SUPPLEMENTAL TESTIMONY OF
DAVID L. SCHREIBER
RANNEY COLLECTOR WATER SUPPLY SYSTEM
SKAGIT NUCLEAR POWER PROJECT
DOCKET NOS. 50-522 & 50-523

A. Introduction

Figure 1 Surface and Groundwater at Skagit Site

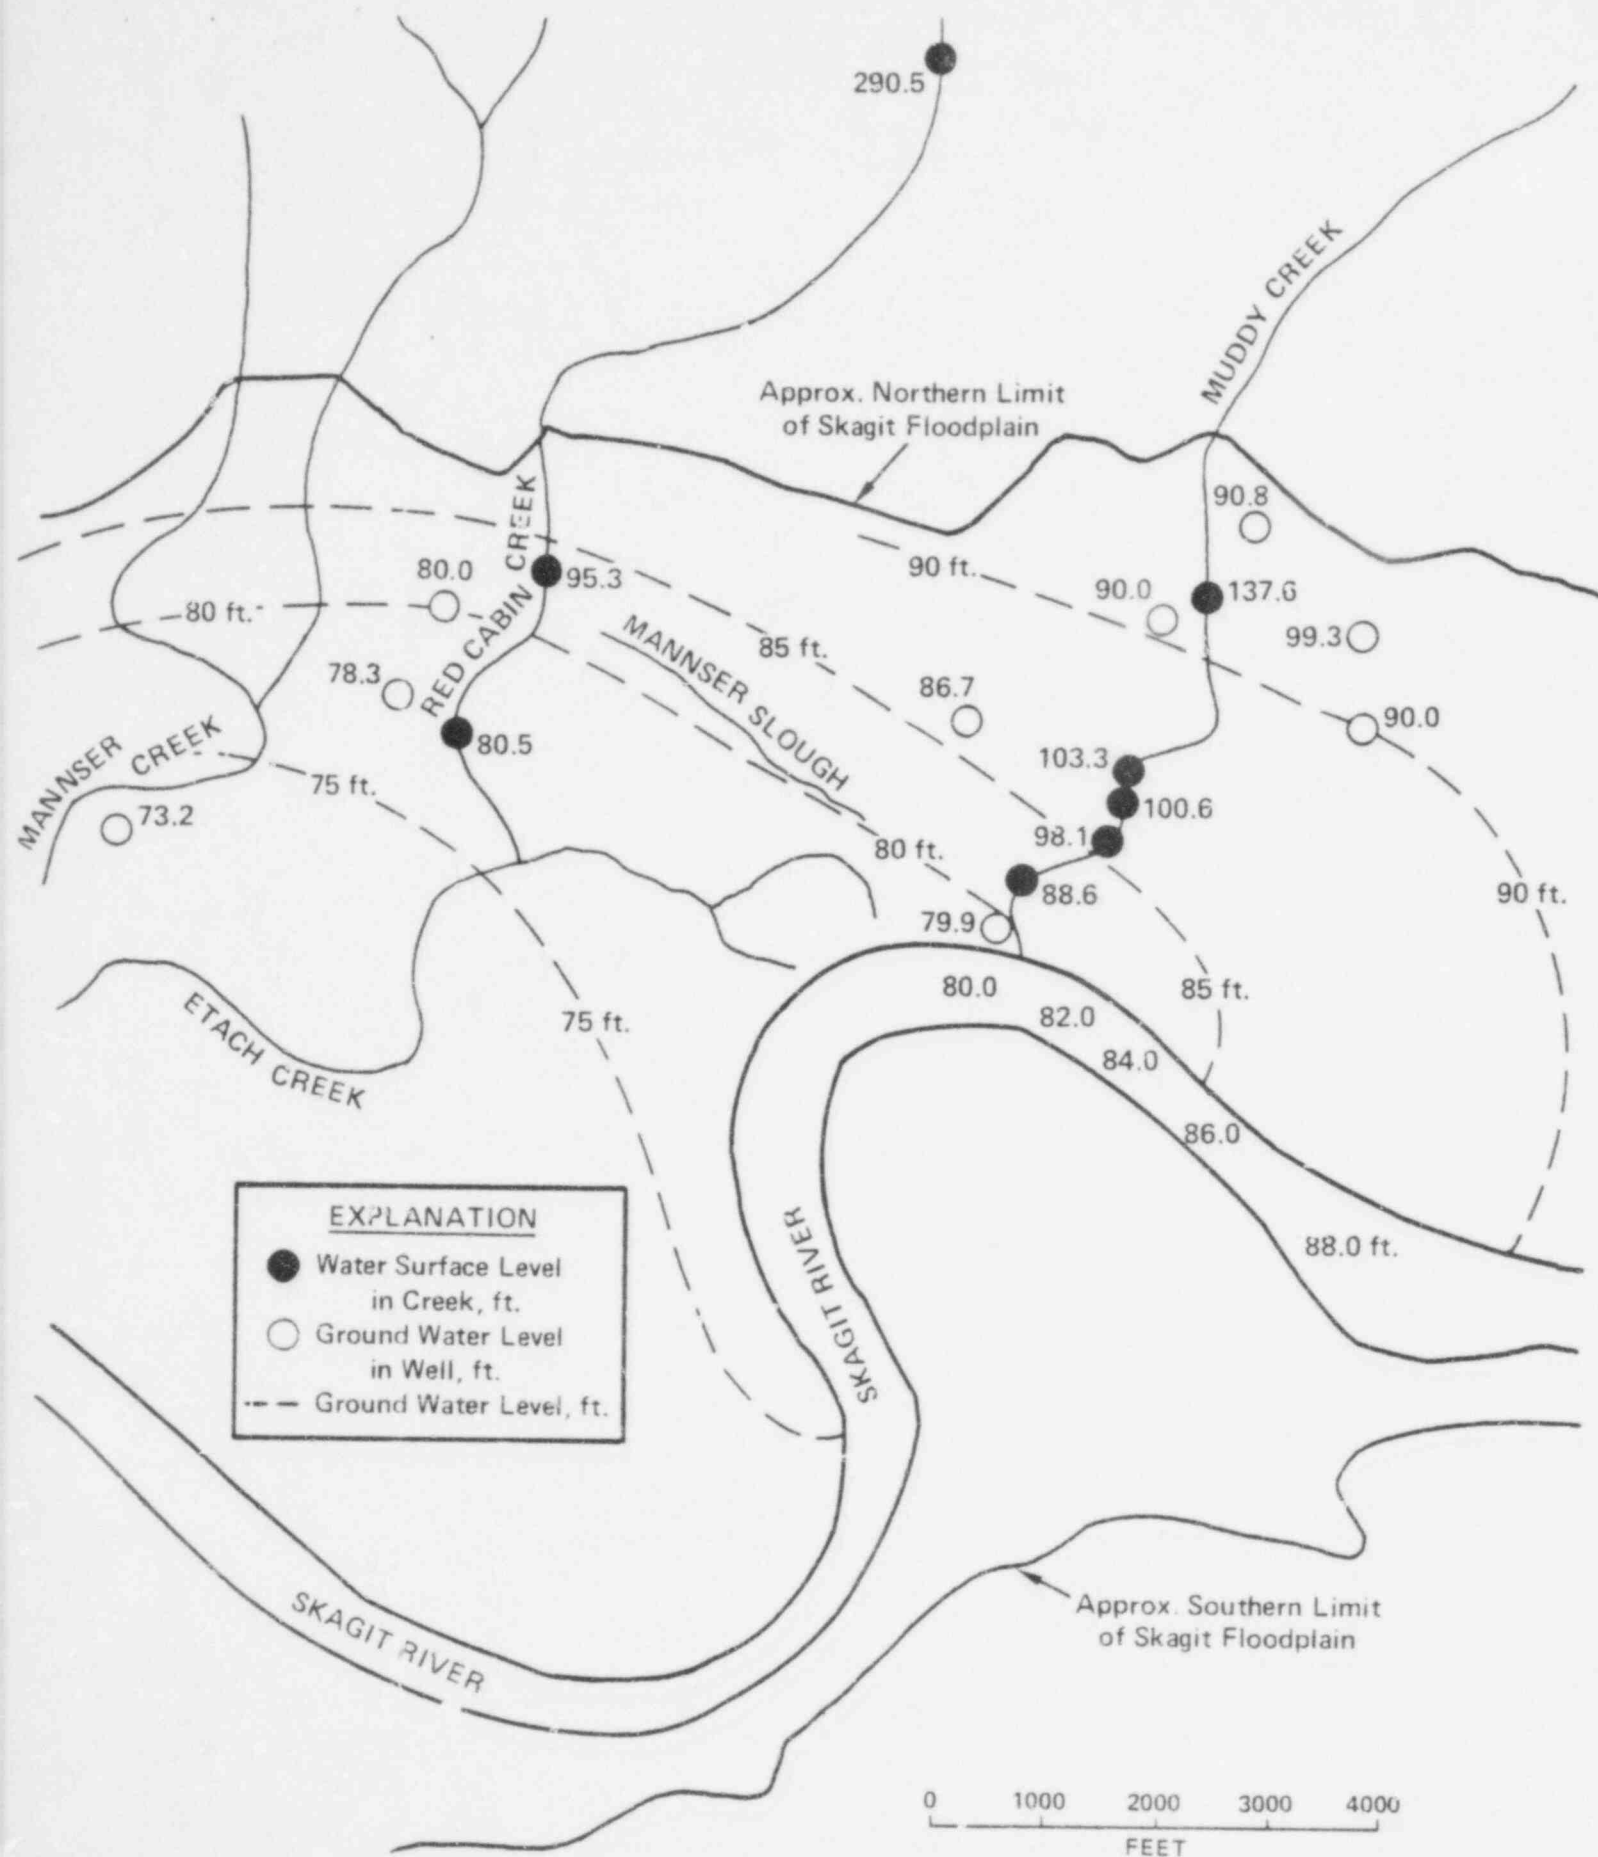
ground-water table elevation contours were sketched on Figure 1 (item 16). Creek bed elevations (Table 3, item 16) were also noted on Figure 1, along with Skagit River water surface elevations (Figure 1, item 9). As evidenced by this Figure, which now includes groundwater table contours, the creek-bed elevations in Red Cabin and Muddy Creeks are everywhere at least several feet above the ground-water table in the Skagit River floodplain. Therefore, the groundwater table drawdown effects of the Ranney Collectors will have no impact on the surface water flowing in either Red Cabin Creek or Muddy Creek.

and debris. The existence of the northern fork of Etach Creek could not be ascertained during the observation period or in aerial photographs (item 17 enclosure). The area where this fork of the creek is depicted on Figure 1 (item 16) did not contain any water, nor were there any indications that water had been there.
